STATE OF MAINE
DEPARTMENT OF TRANSPORTATION
16 STATE HOUSE STATION
AUGUSTA, MAINE 04333-0016

October 18, 2024
Subject: Ferry Terminal Rehabilitation
Location: Casco Bay
State WIN: 024685.01
Amendment No. 2

FERRY TERMINALS AT CHEBEAGUE,
CLIFF, GREAT DIAMOND AND PEAKS
ISLANDS

S10

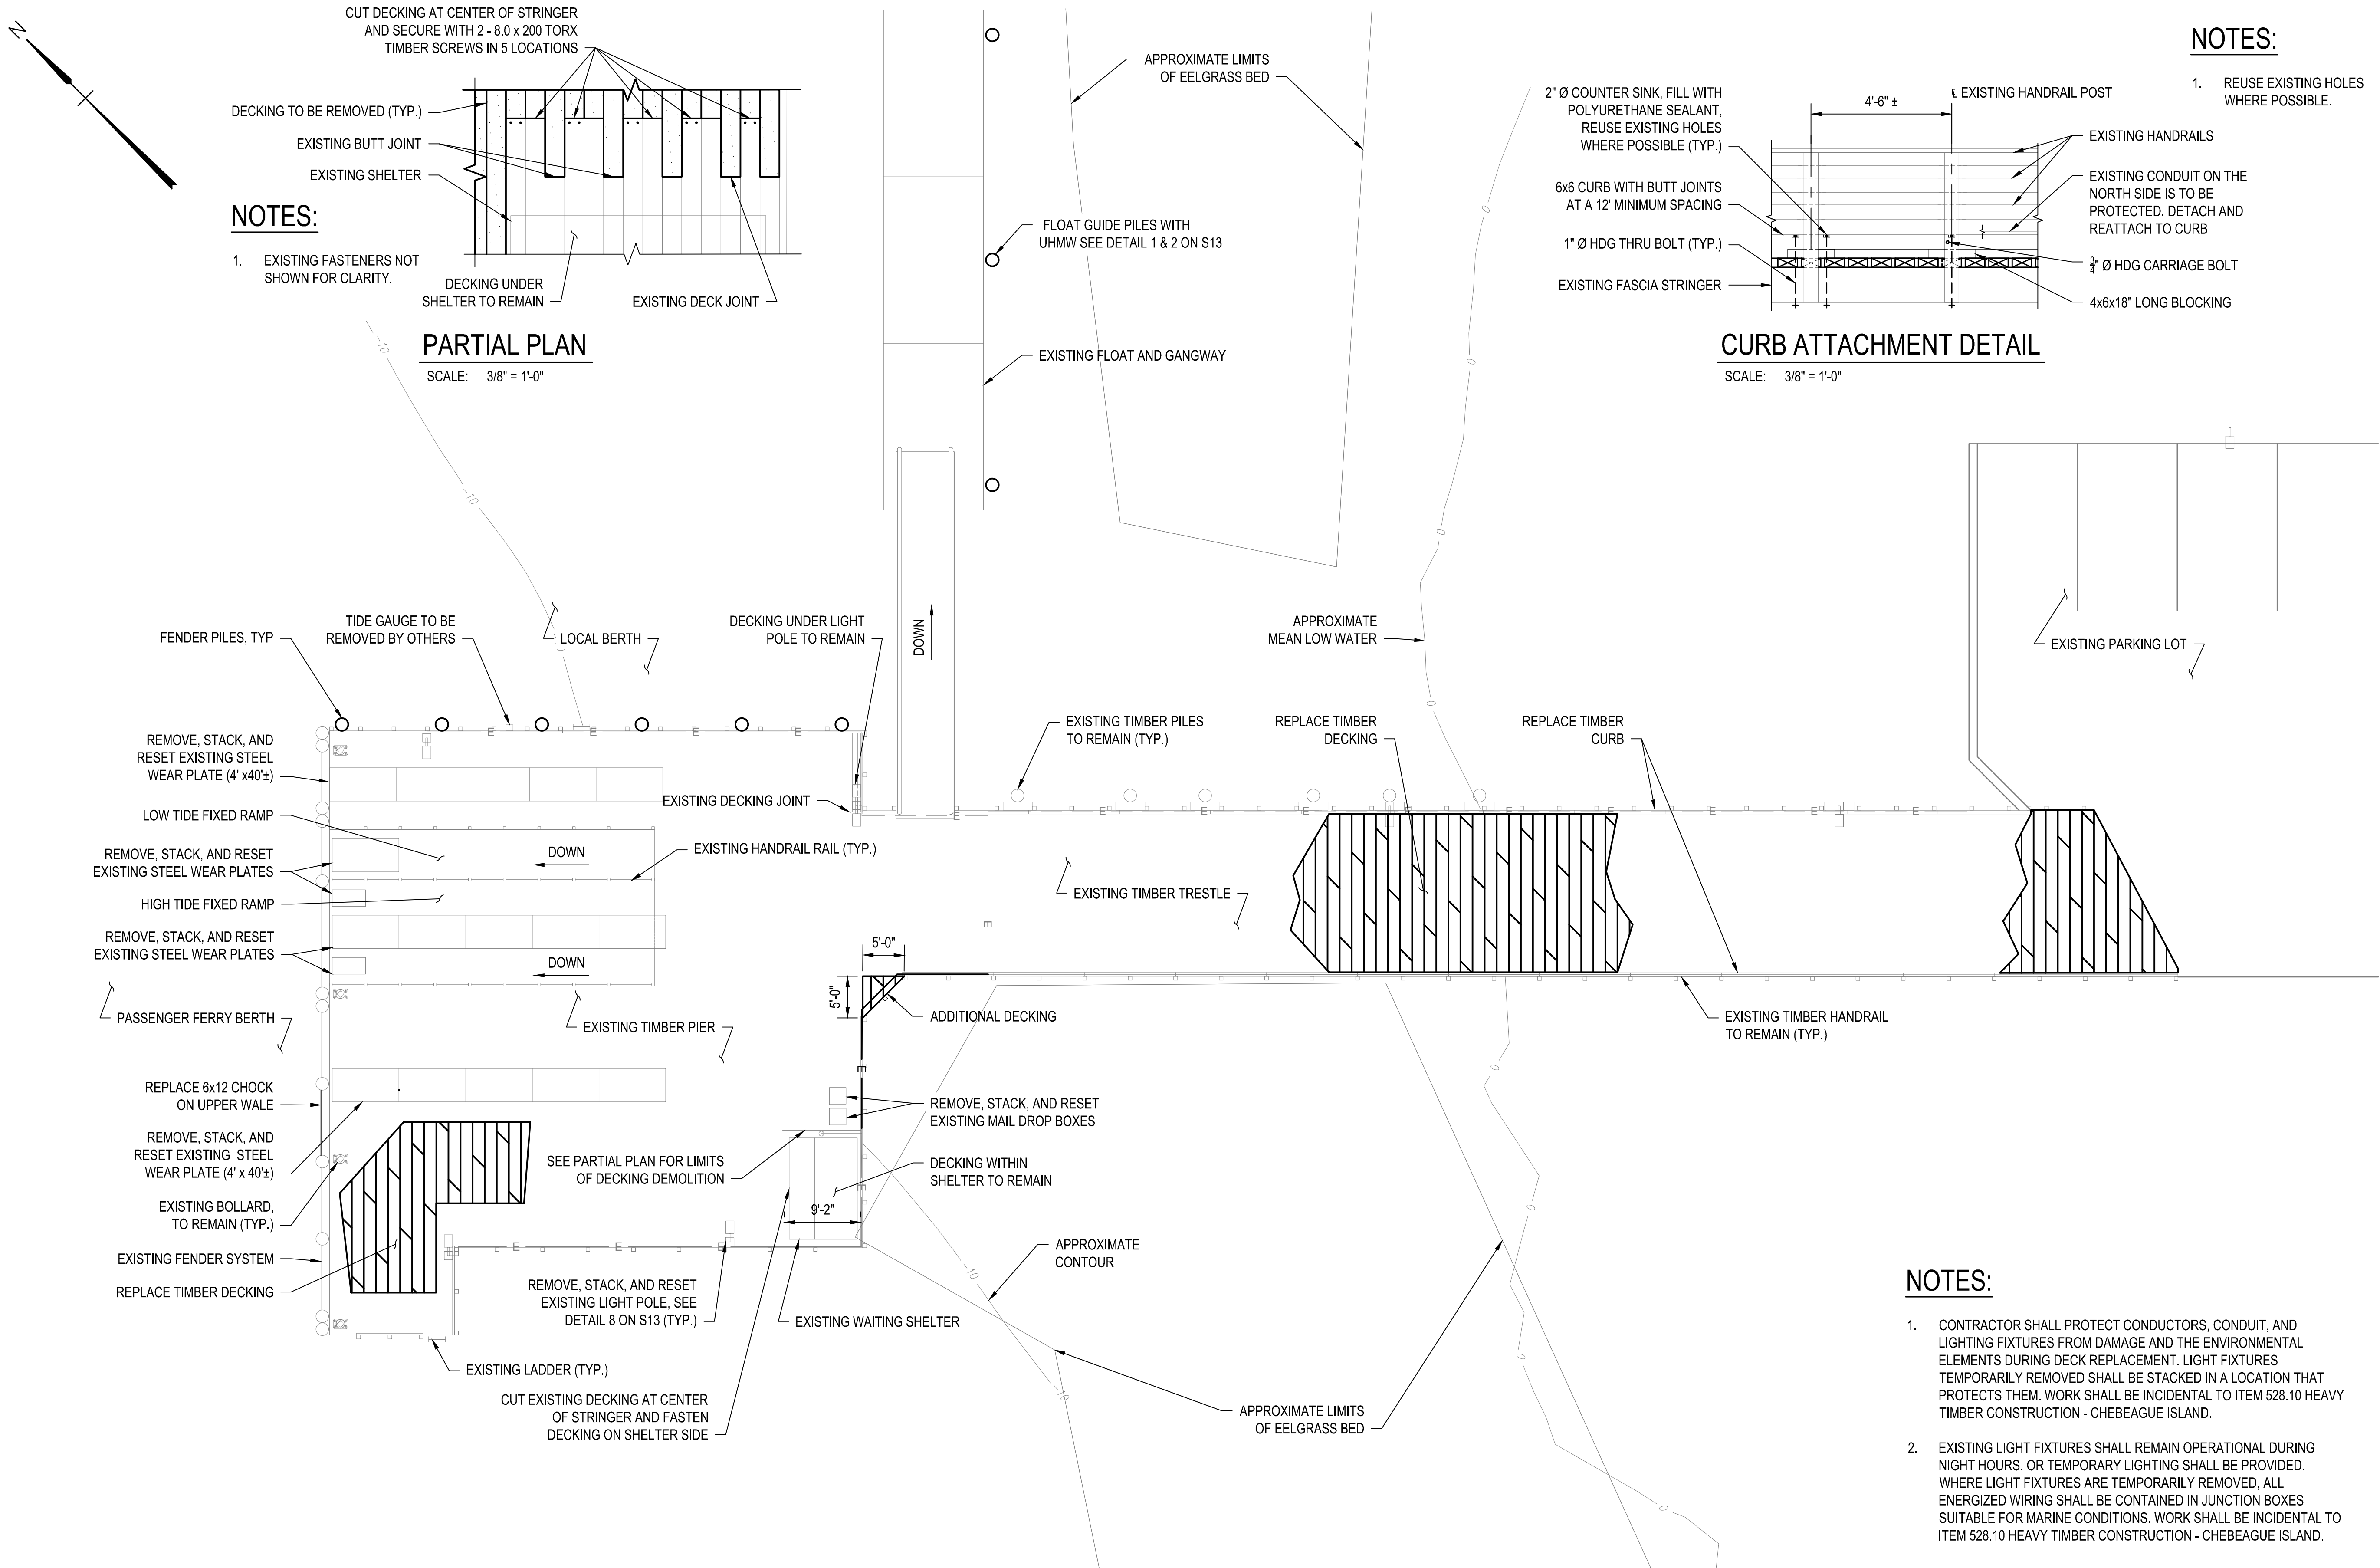
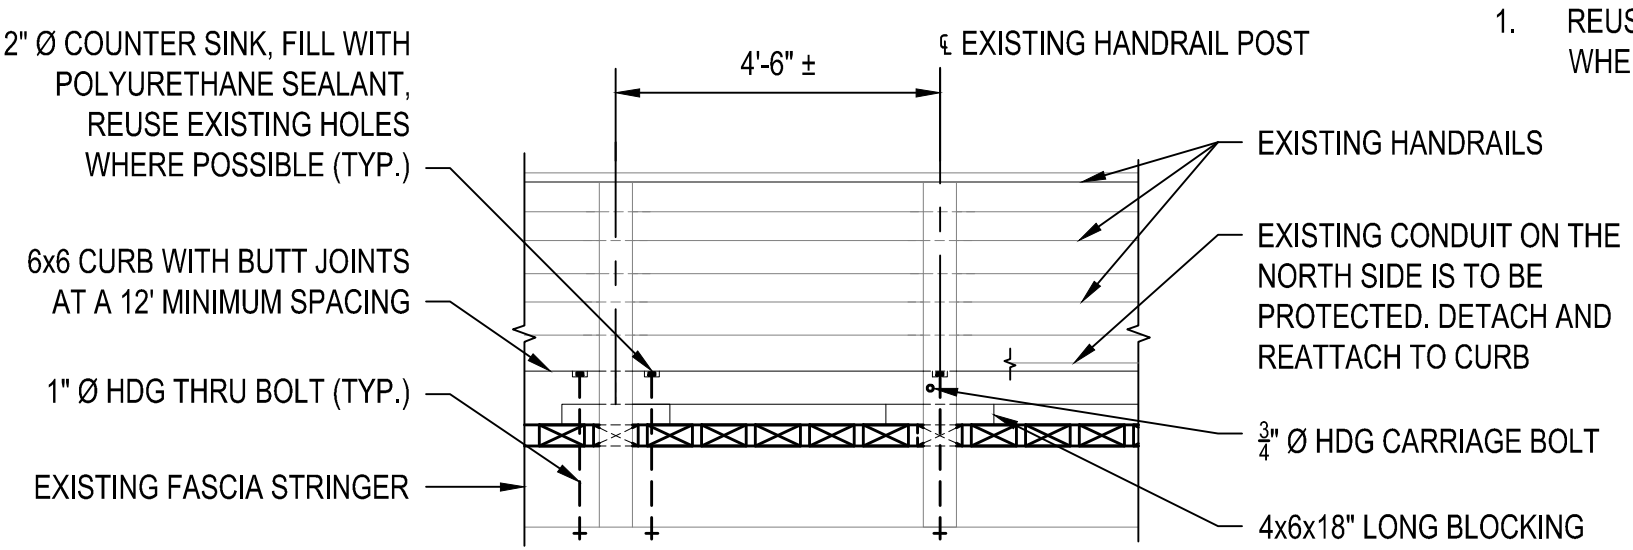
Question: When quantifying the amount of 4x8's and 4x10's required to replace all pier decking for the Great Diamond Island Terminal, it was noticed that the board-feet amount calculated was significantly different from the board-feet unit quantity shown on line # 0230 on the MEDOT schedule of values provided. On Sheet number S6, there is a note stating that all pier decking is to be replaced, minus the decking under the shelter and decking for the ramp. Is the Unit quantity on Line # 0230 incorrect? Or does the pier decking scope differ from what is stated on this drawing?

Response: See Partial Plan Detail on Sheet S6 and S10 for clarification of deck replacement around existing shelters. Pier Decking shall be paid for under Item 528.10 Heavy Timber Construction – Great Diamond Island as a Lump Sum. See Special Provision 528 – Structural Timber that has been replaced in its entirety.
